Job Sheet 171201

ENGINEERING CHANGE NOTICE NO. 04948

DWG TITLE: DEFLECTORS

REASON: REVISED TOLERANCE AND NOTES

SHEET 1, ZONE B1 IS:

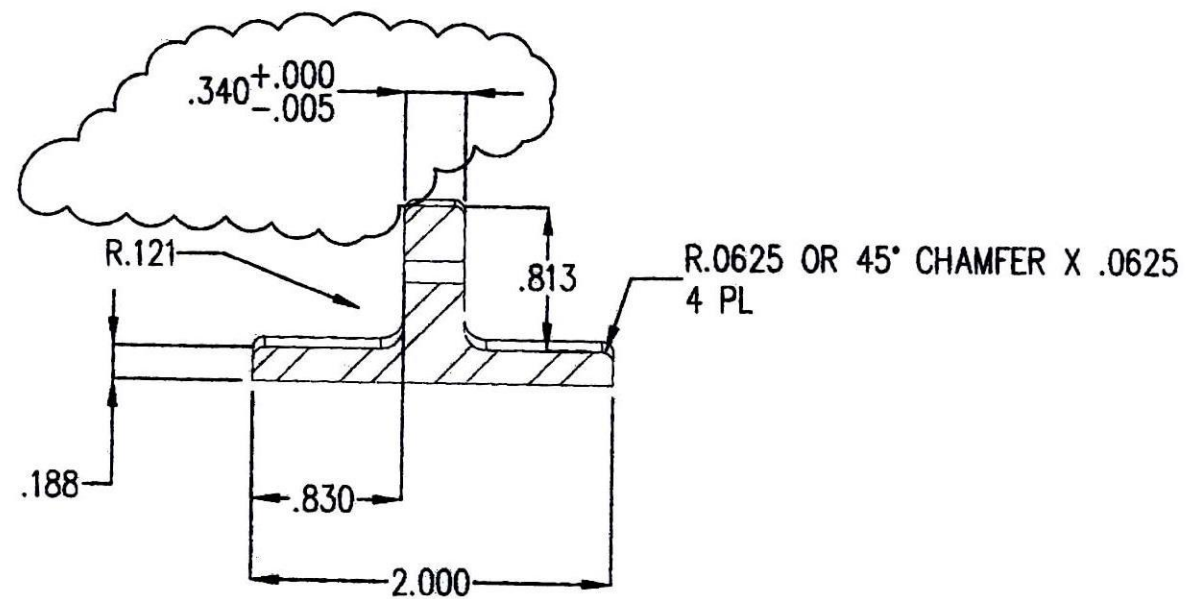
- 1 MATERIAL: ALUMINUM 7075-T651 PER AMS-QQ-A-250/12.
- 2 FINISH: HARD ANODIZE IAW MIL-A-8625 TYPE III, CLASS 2, COLOR BLACK;
3. DEBURR AND BREAK ALL SHARP EDGES.
4. IDENTIFY IAW MPP-120.
- 5 APPLY F/N 3 AS REQUIRED TO ALL FAYING SURFACES OF F/N 6, 7 & 8 UPON ASSY.
- 6 MAXIMUM OR MINIMUM DIMENSION AFTER FINISH.
7. .0625 HOLE MAY BE ADDED FOR FINISHING PURPOSES
- 8 FINISH: PRETREAT PR-148 ADHESION PROMOTER, PRIME IAW MIL-P-23377J, TYPE I, CLASS N; 1-2 MIL MAX. APPLY FINISH AFTER ASSEMBLY.
- 9 FINISH: PRETREAT PR-148 ADHESION PROMOTER, PRIME IAW MIL-P-23377J, TYPE I, CLASS N; 1-2 MIL MAX.
- 10 MATERIAL: ALUMINUM 2024-T3 PER AMS-QQ-A-250/4.

SHEET 11, ZONE C1 IS:

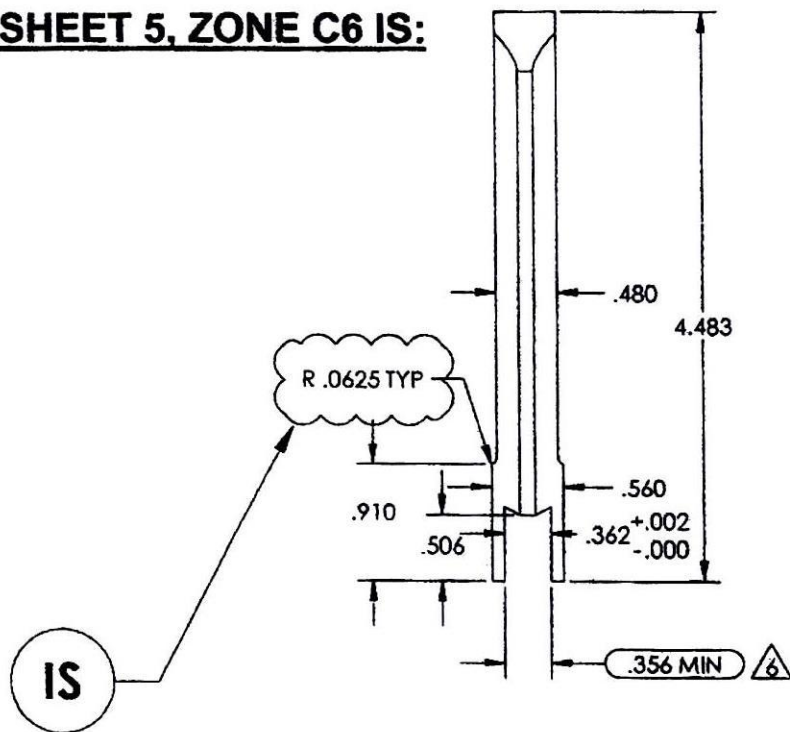
APICAL INDUSTRIES, INC.	ENGINEERING CHANGE NOTICE NO. 04556		SHEET 1 OF 2	
	DWG NO. 647.3900	REV: C	PREPARED BY D. MEJIA	DATE: 06/10/2014
	DWG TITLE: DEFLECTORS			
	APPROVED BY: ENGR <i>[Signature]</i>	MFG <i>[Signature]</i>	QC <i>[Signature]</i>	EFF. NEXT ORDER
TRANSACTION CODES (TC): A-ADD C-CREATE R-REVISE D-DELETE	REASON: CHANGED P/N, DIMENSIONS & REVISED BOM			ECR: D-14-04
